for the Maywood Site, New Jersey

**ADDENDUM TO THE MAYWOOD SITE FIELD SAMPLING PLAN FOR WESTERLY BROOK/SADDLE RIVER**

ADDENDUM TO MAYWOOD SITE  
FIELD SAMPLING PLAN FOR WESTERLY BROOK/SADDLE RIVER

Figure 1. Offsite Surface Water and Sediment Sampling Locations for MISS

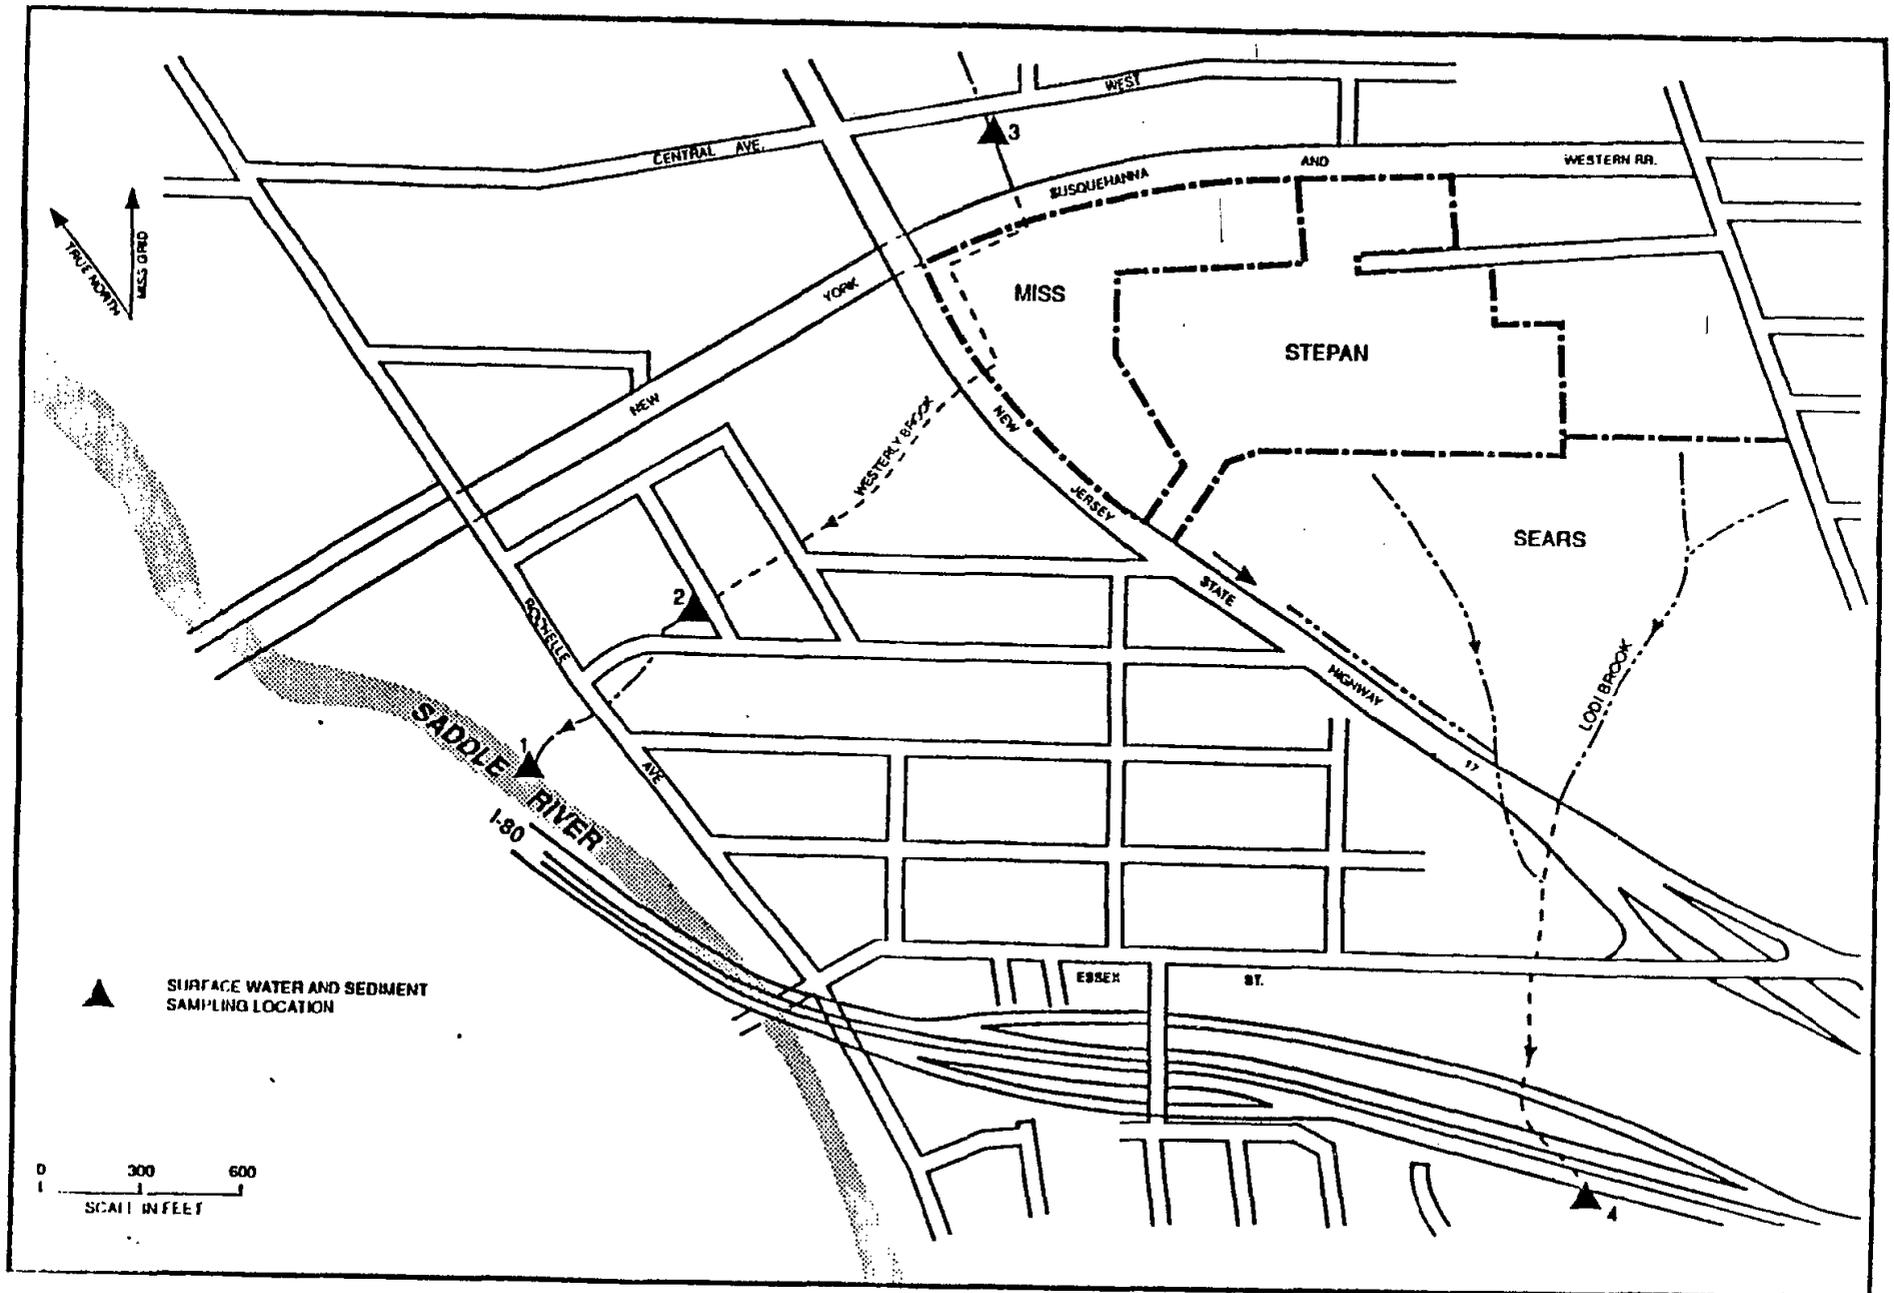
Quarterly surface water and sediment samples have been collected at three locations in Westerly Brook and one location along Lodi Brook since 1986 (Figure 1). The samples have been routinely analyzed for radioactivity (total uranium, Ra-226, Th-232), indicator parameters (total organic carbon, total organic halide, pH, specific conductance) and, during recent sampling in conjunction

Downstream (locations 1 and 2, Figure 1) surface water sample concentrations of radiological contaminants and metals were similar to those concentrations found at the upstream sampling location (location 3). The only metal that exhibited concentrations above the upstream location sample was lithium. Volatile organic contaminant concentrations above those at the upstream location were reported for carbon tetrachloride, 1,2-dichloroethene, trichloroethene, and tetrachloroethene. Although none of these chemicals have been directly associated with thorium processes, these compounds have been detected in offsite groundwater monitoring wells downgradient from MISS. It is suspected that the above-mentioned chemical contaminants are migrating from MISS or being introduced into surface water via groundwater infiltration. If these contaminants originate at MISS, then DOE is responsible for addressing these contaminants as FUSRAP waste, as identified in the Maywood Site FFA.

The nature and extent of historical contaminant migration and deposition in the Westerly Brook and Saddle River floodplain have not been addressed to date. Analogy between the distribution of radiologically contaminated sediments along Lodi Brook (Figure 1) and the particle-reactive nature of the likely contaminants from MISS (e.g., thorium, uranium) suggests that, if depositional areas existed along the route of Westerly Brook during operations of the Maywood Chemical Works, than radiologically contaminated sediments may have been similarly distributed.

Figure 2. 100-yr and 500-yr Floodplains Associated with Westerly Brook and Saddle River

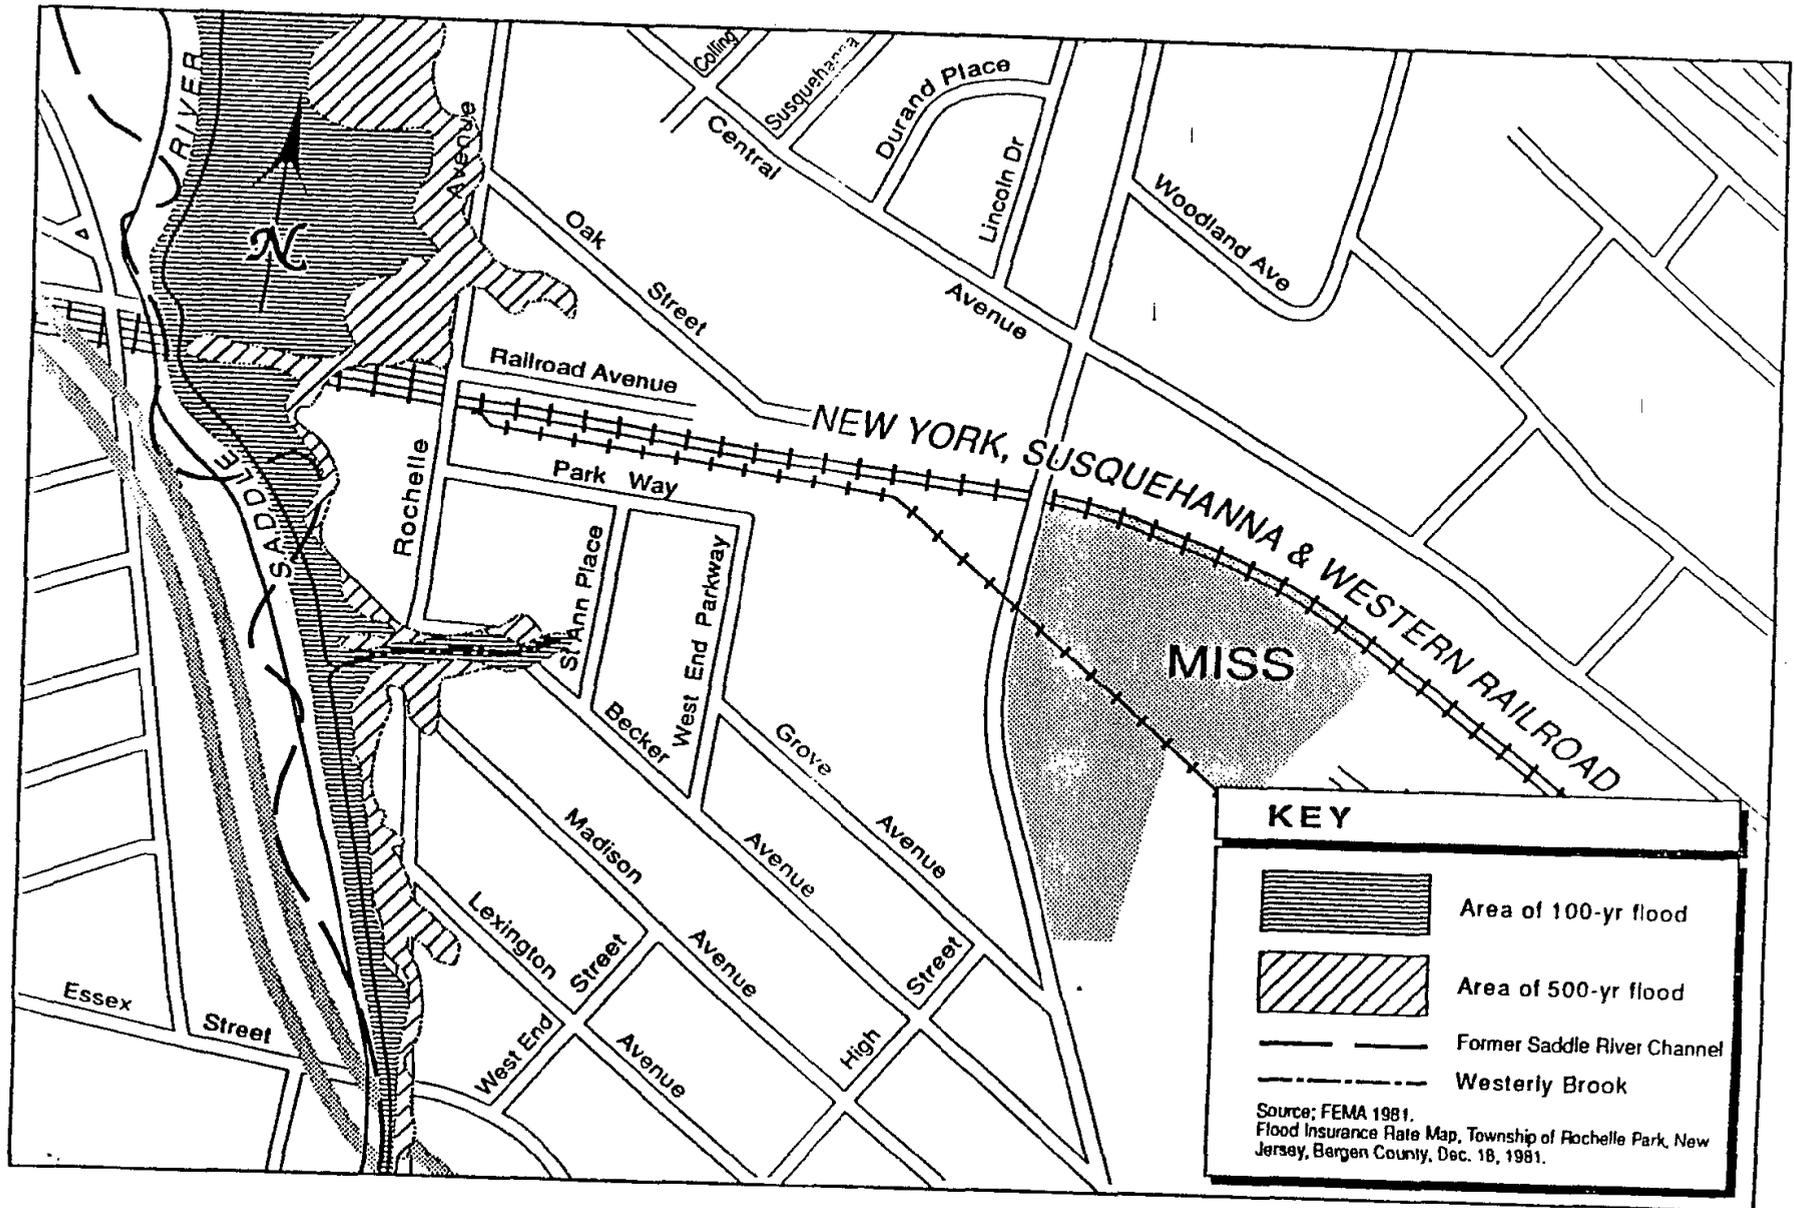
After a recent visual inspection of accessible portions of Westerly Brook and Saddle River and examination of aerial photographs and topographic and floodplain maps of the area (Figures 2 and 3), historical sediment depositional zones have been identified along the Saddle River near its confluence with Westerly Brook (Figure 2). The locations have been ranked according to the likelihood that historical deposits from Westerly Brook exist at each site, are accessible, have not been altered by construction activities, and may be sampled (Figure 3). Location 1 is on an elevated floodplain just downstream of the confluence with Westerly Brook. Locations 2 and 3 are further downstream in areas that, according to older topographic maps, were depositional zones in Saddle River meander bends. The major drawback to locations 2 and 3 are that they are near Interstate 80 highway and have been more directly impacted by construction and fill activities. Though final field sampling locations will be chosen in the field, investigative results thus far indicate that sampling in the Saddle River flood zones will probably take place only in the area around location 1.

No floodplain areas were identified for sampling along the open reaches of Westerly Brook. The deeply incised nature of the stream channel suggested that flooding of adjacent areas may be infrequent (Figure 2). However, rising water levels within the channel may carry significant amounts of particle-bound contamination downstream. Based on radiological survey results from another DOE facility (Paducah Gaseous Diffusion Plant, Paducah, Kentucky), it is possible that
